August 19, 1983

SUBJECT: INTEGRATED PLANT SAFETY ASSESSMENT REPORT (IPSAR)
SECTION 4.5, PLANT FLOODING BY DEER CREEK -
R. E. GINNA NUCLEAR POWER PLANT

R. E. GINNA NUCLEAR POWER PLANT
IPSAR SECTION 4.5
PLANT FLOODING BY DEER CREEK

Figure 3. Mean Annual Peak Discharge versus Watershed Area for New York State Small Watersheds near R.E. Ginna Nuclear Power Plant

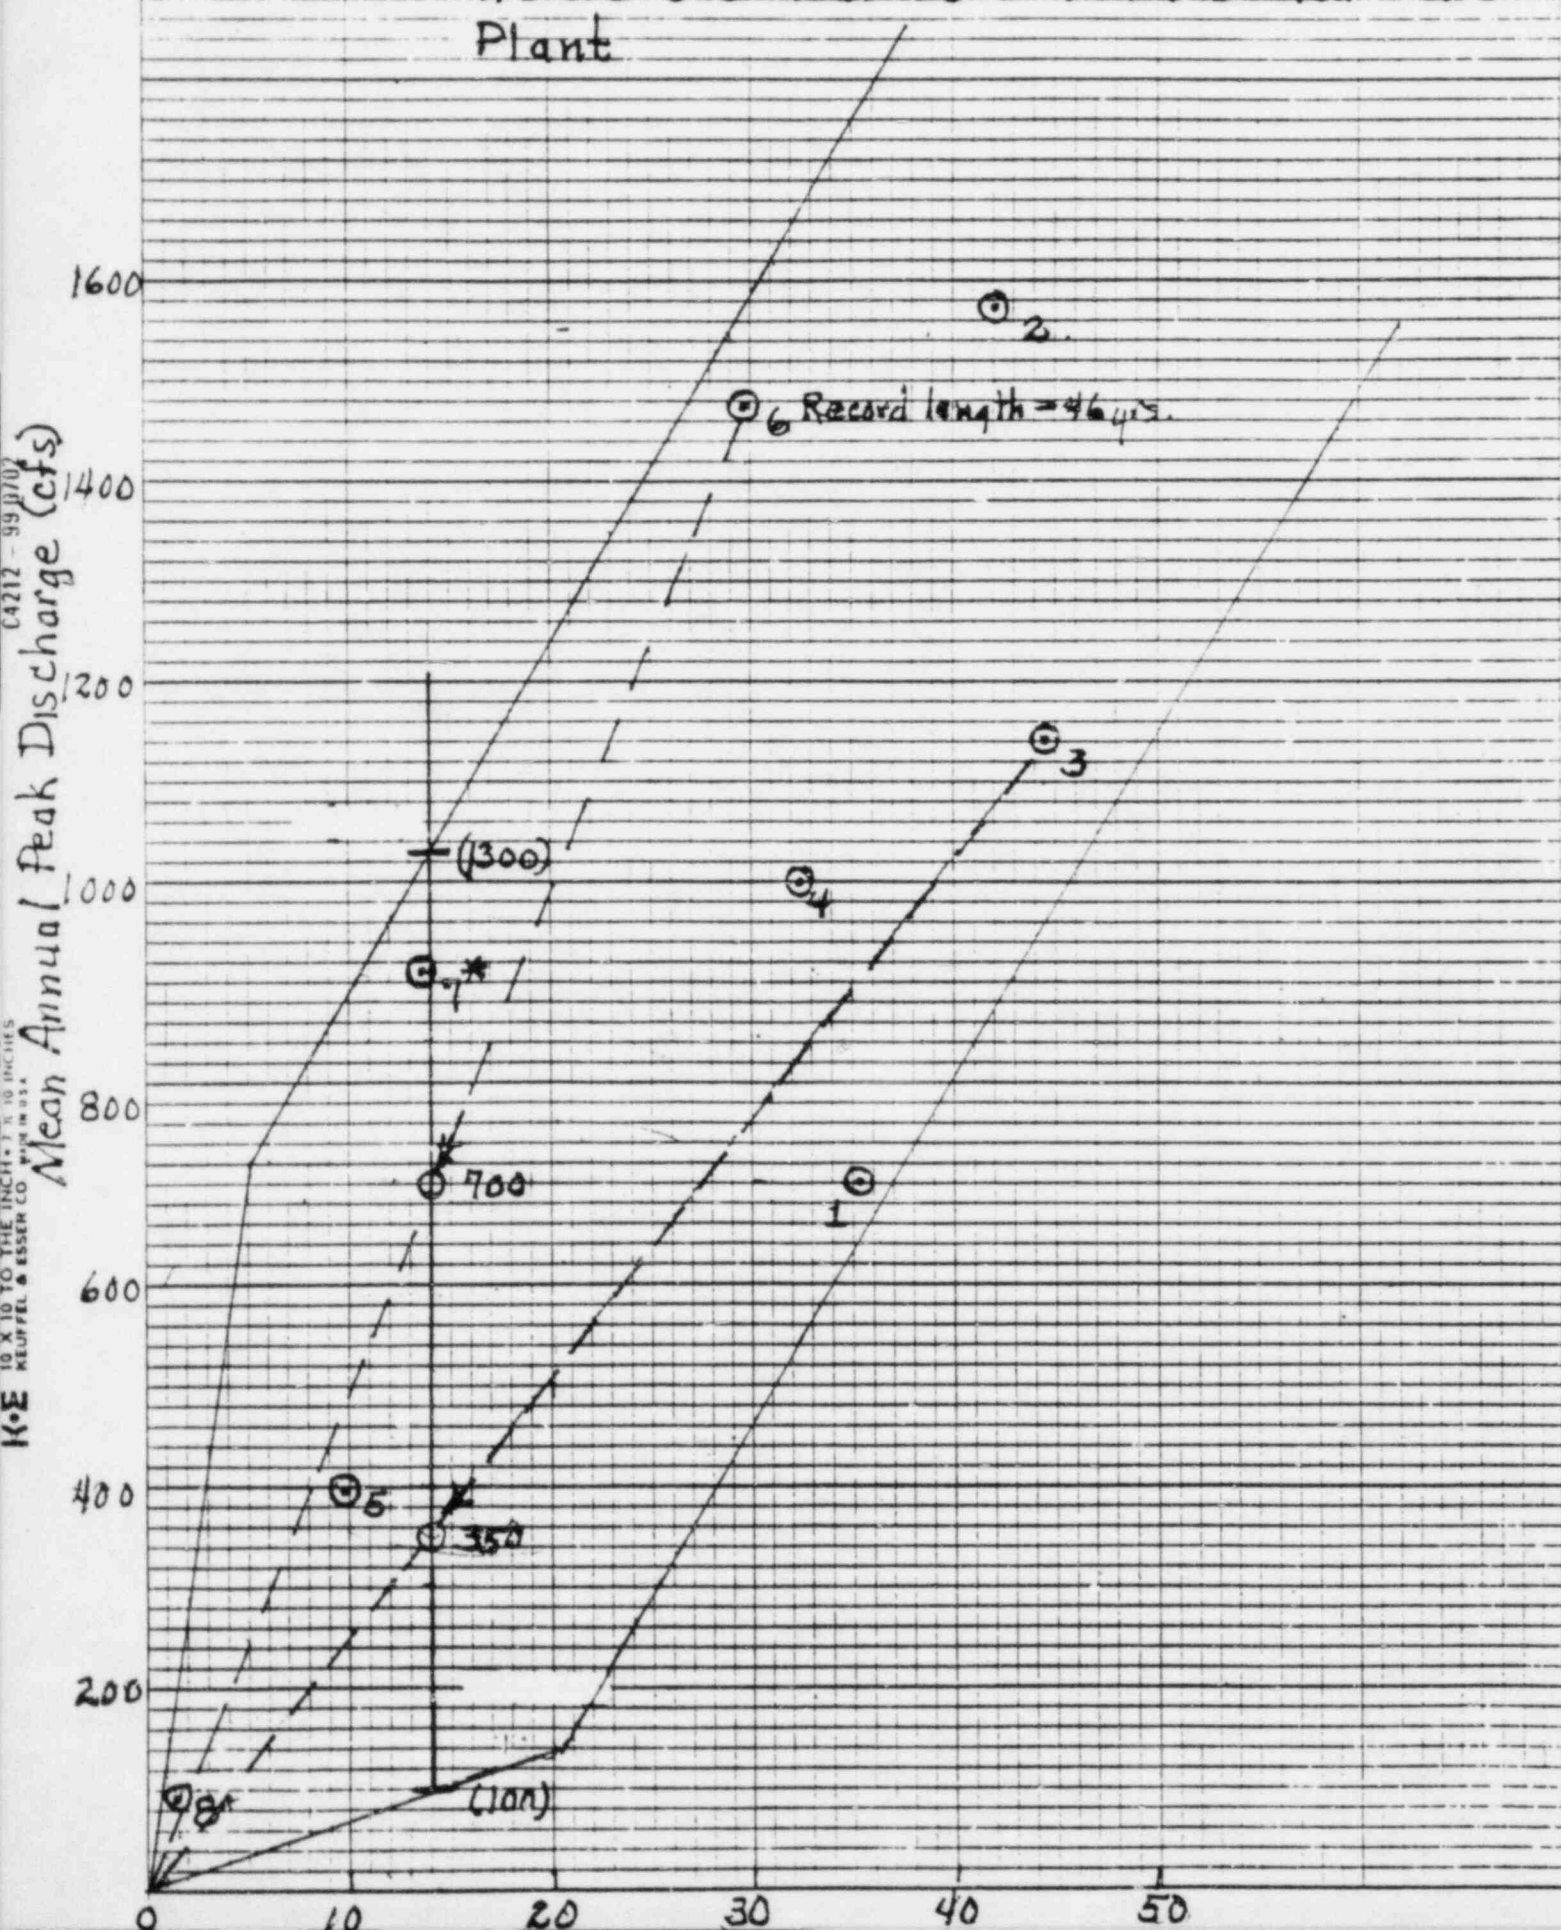
The predicted discharges for given recurrence probability depends on the mean annual maximum flow (\bar{Q}_{am}) from the ungaged Deer Creek watershed. The discharges for a sequence of probabilities from 10^{-2} to 10^{-8} and a range of \bar{Q}_{am} from 100 to 1300 cfs are shown in Table 1. The mean annual maximum discharge (\bar{Q}_{am}) of the eight gaged watersheds have been plotted versus watershed area in Figure 3. A solid vertical line has been placed on the figure at area equal 13.9 (the area of the ungaged Deer Creek watershed) between

\bar{Q}_{am} of 100 and 1300 cfs. Lighter solid lines envelope the points of the eight gaged sites. By virtue of location, point number 3 appears to be most similar watershed to the Deer Creek watershed and if a straight line is drawn between it and the origin it crosses the Deer Creek line at $\bar{Q}_{am} = 350$ cfs. However, using the station with the longest period of record (no. 6) and projecting back to the origin, a \bar{Q}_{am} of 700 cfs is measured at the Deer Creek line. Note that one of the watersheds near the Catskills with an area of 13.9 mi² has a \bar{Q}_{am} of 911 cfs. From Table 1, the proposed protection level (26,000 cfs) has a probability of occurrence of less than 10^{-8} for a \bar{Q}_{am} of 350 cfs, but increases to slightly less than 10^{-2} for \bar{Q}_{am} 900 cfs and to somewhat less than 10^{-5} for an arbitrary top end of the calculated range of \bar{Q}_{am} equal 1300 cfs. Note in Figure 2 that with the amount of information available and analysis done, the two watersheds may be in a separate group from the others or just part of a wide continuum, but whatever the situation, the inclusion of these data add another degree of conservatism to the analysis. The probability of occurrence for the other levels of flooding (site flooding, standard project flood [SPF] and the probable maximum flood [PMF]) can also be interpreted from Table 1. Based on this analysis, the probability of flooding beyond the level of protection appears to be sufficiently low.

Figure 4. Peak Discharge at Deer Creek vs. Exceedance per 1000 yr.

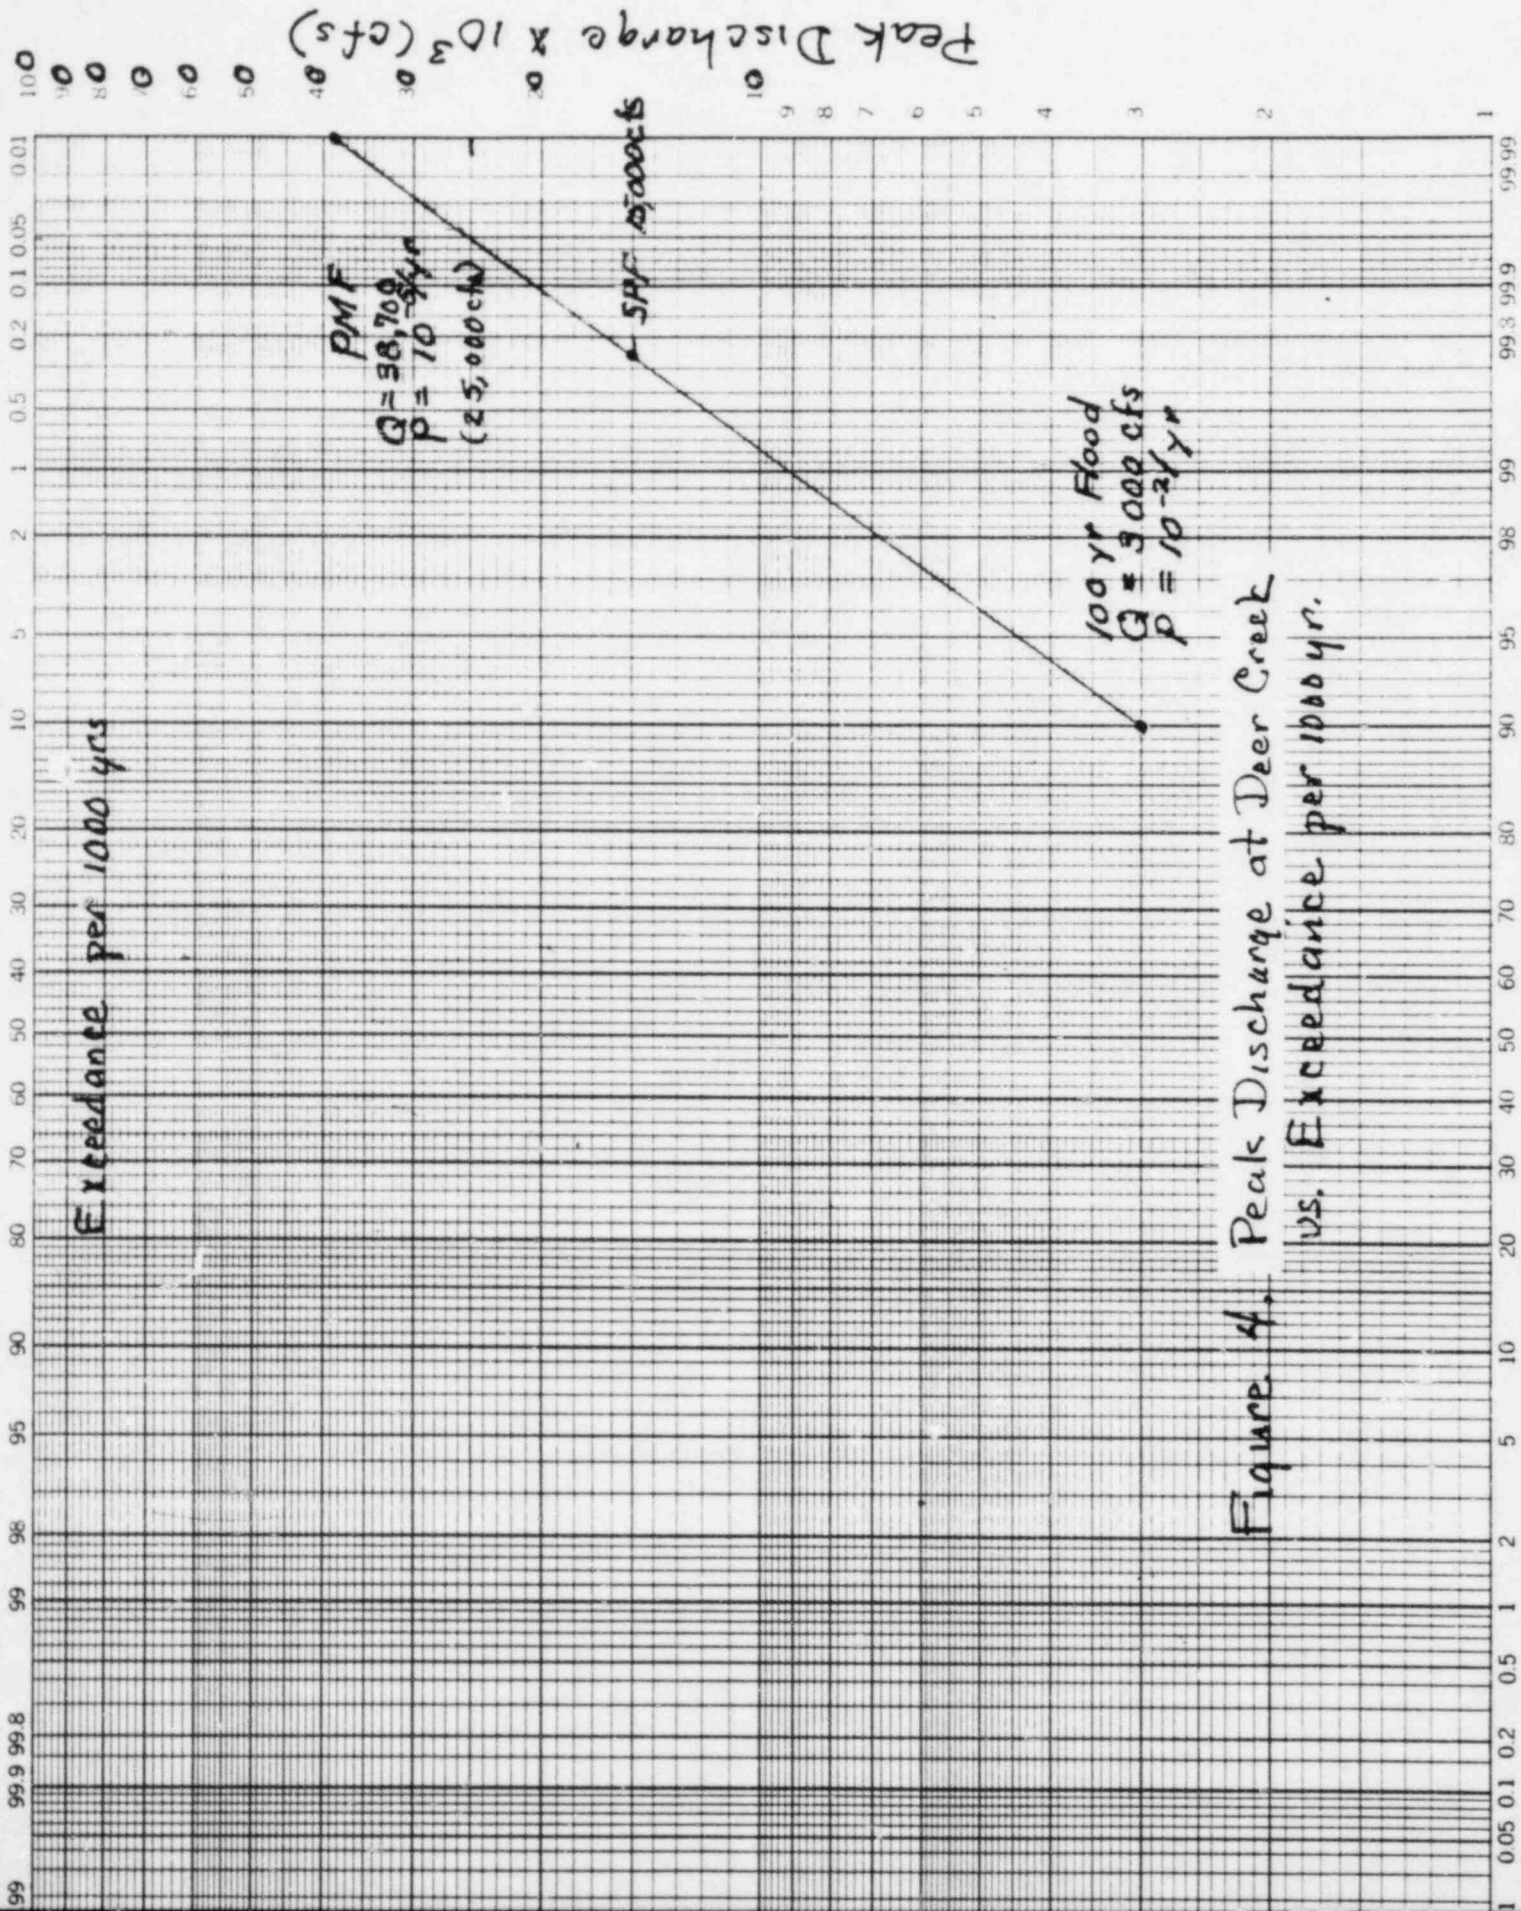
1. The flood flow in Deer Creek corresponding to el 273.8 is 25,000 cfs as determined by the staff (licensee's estimate was 26,000 cfs).
2. The exceedance probability of the PMF is no greater than 10^{-5} per year.
3. A conservative estimate of the PMF is 38,700 cfs.
4. The 100 year flood is about 3,000 cfs.
5. The probability of any flow between the 100 year flood flow and the PMF can be approximately estimated by a straight line interpolation on log-normal probability paper (Figure 4).

From this plot of the 100 year flood and the PMF on log-normal probability paper, the exceedance probability of a flood flow of 25,000 cfs on Deer Creek was determined to be about 5×10^{-5} per year.

The equipment required for safe plant shutdown is located in the auxiliary building and turbine building. The licensee has committed to provide protection in this area to 273.8 ft msl, 1.4 ft below the staff's PMF in this area of 275.2 ft msl. The staff believes that its PMF estimate may be very conservative. Because the probability of flooding beyond the proposed level of protection is low, it is the staff's judgment that this accident sequence would not dominate events leading to core melt. In addition, based on the licensee's cost estimates, the staff concludes that additional protection would not be cost-effective. Therefore, the staff concludes that the licensee's proposal is acceptable.

However, in order to assure that the proposed flood protection can be achieved, the staff will require that the licensee develop associated emergency procedures. These procedures should identify a point at which the flooding elevation corresponds to approximately 10,000 cfs, at which time the plant personnel should begin installing the flood protection devices. Installation should be complete within 45 minutes thereafter, to ensure they will be in place well before the rising floodwater jeopardizes safe shutdown capability.
